**Quanta Project Name: JX6**  
**Dell Project Name: MGD Lite**  
**2007-03-01**  
**REV : D3B**  
**A00/X-Build Stage**

# JX6 MGD-INTEGRATED

<b>QUANTA COMPUTER</b>		
Title: Changed List P01		
Size:	Document Number: MGD	Rev: 1A
Date:	Thursday, March 01, 2007	Sheet 54 of 89

Title		
3VALW.5V.3V, Power On		
Size	Document Number	Rev
MGD		3A
Date:	Thursday, March 01, 2007	Sheet 47 of 89

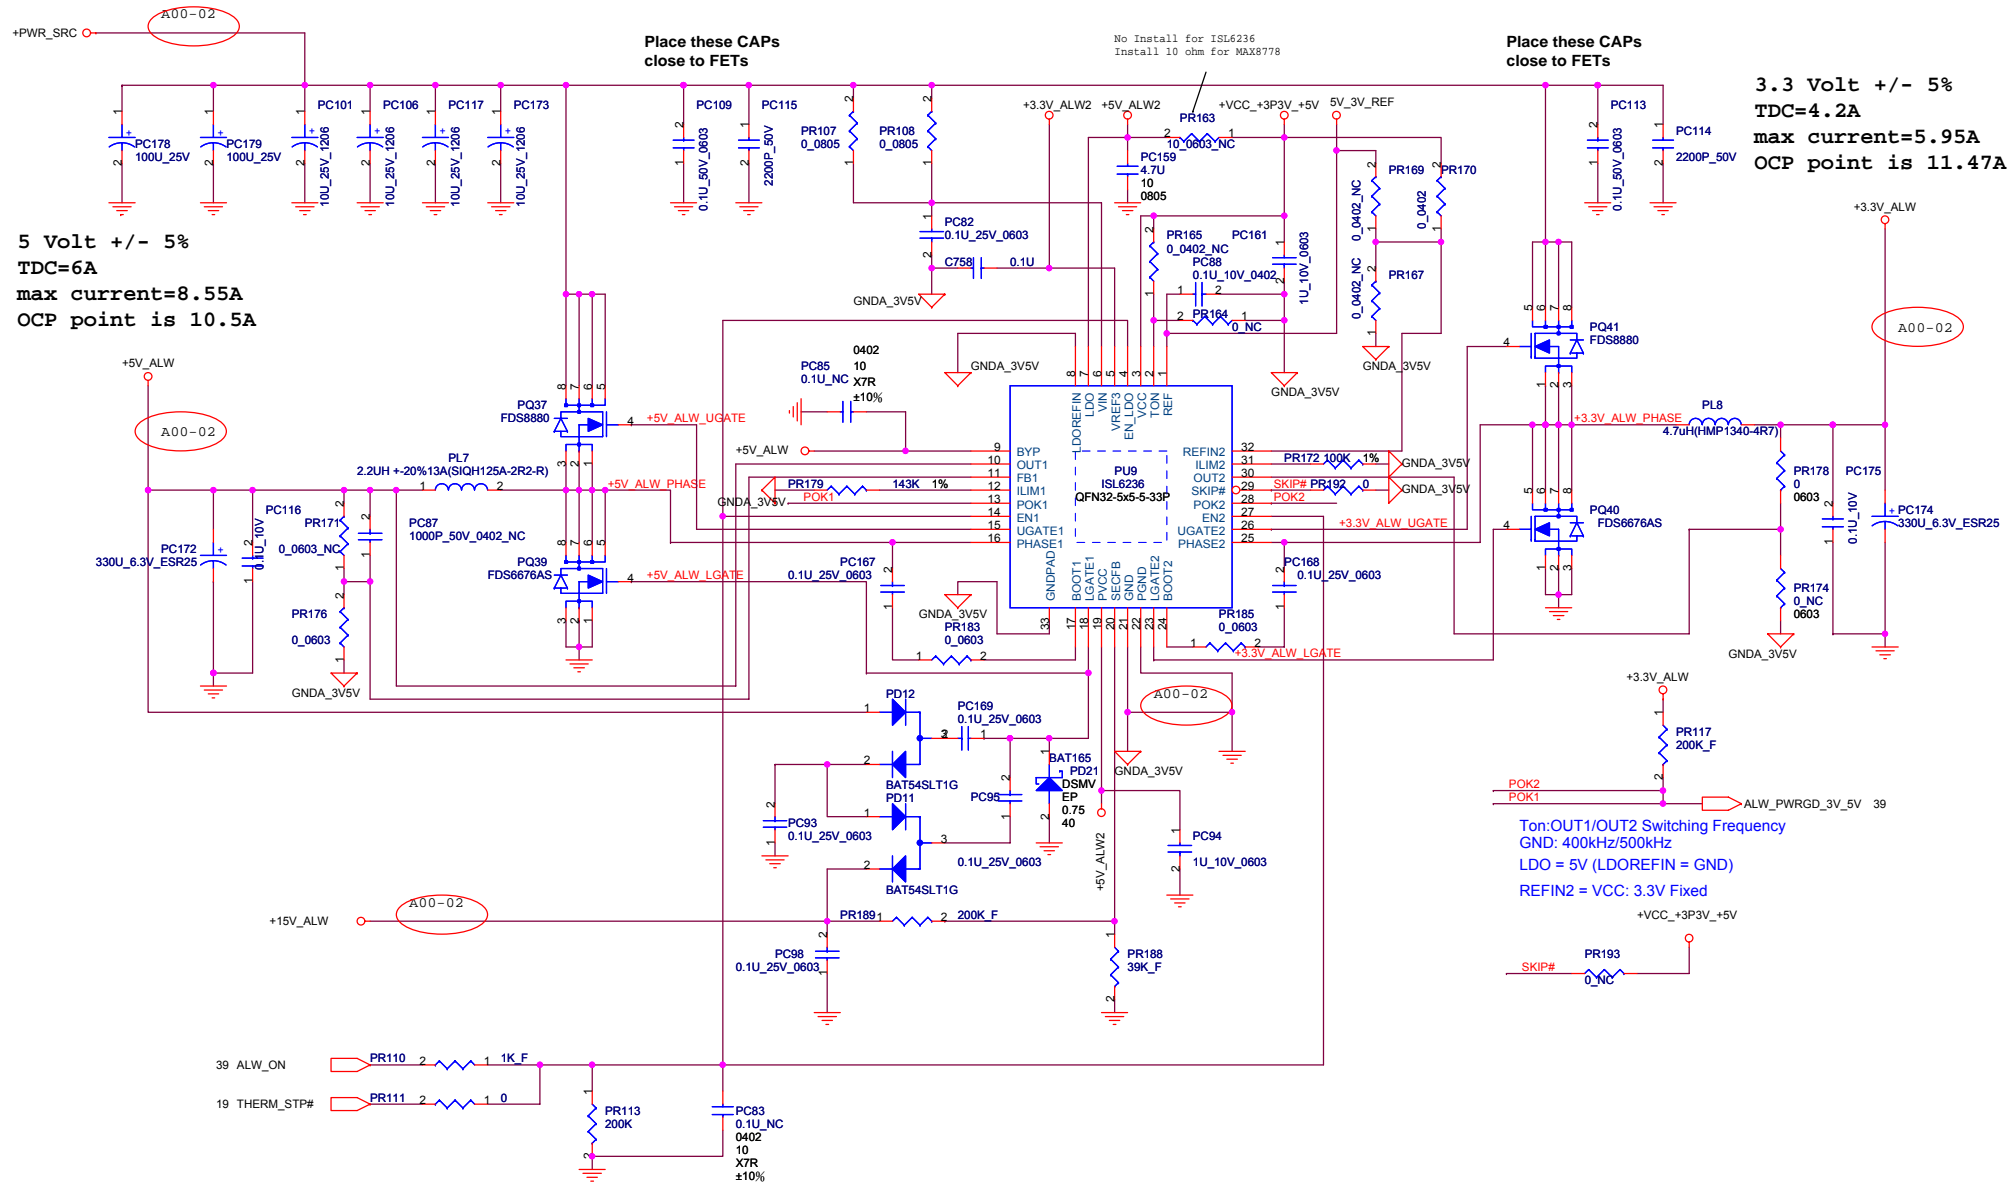
111006W  
 Page 47  
 For system power regulator schematic change  
 1. change PR179 from 154k to 143k, PR172 from 178k to 100k  
 to adjust current limit setting.  
 2. change PL8 from SIQH125A-2R2 to HMP1340-4R7  
 3. depop PR164 to set 3V regulator switching frequency to 300kHz.  
 4. add a 0\_0402(PR192) resistor from PU9.29 (skip#) to GNDA\_3V5V  
 for optional ultrasonic mode per ref. schematic rev. A04  
 5. schematic clean-up: 5V rail max current=8.55A, TDC=6A;  
 3.3V rail max current=5.95A, TDC=4.2A
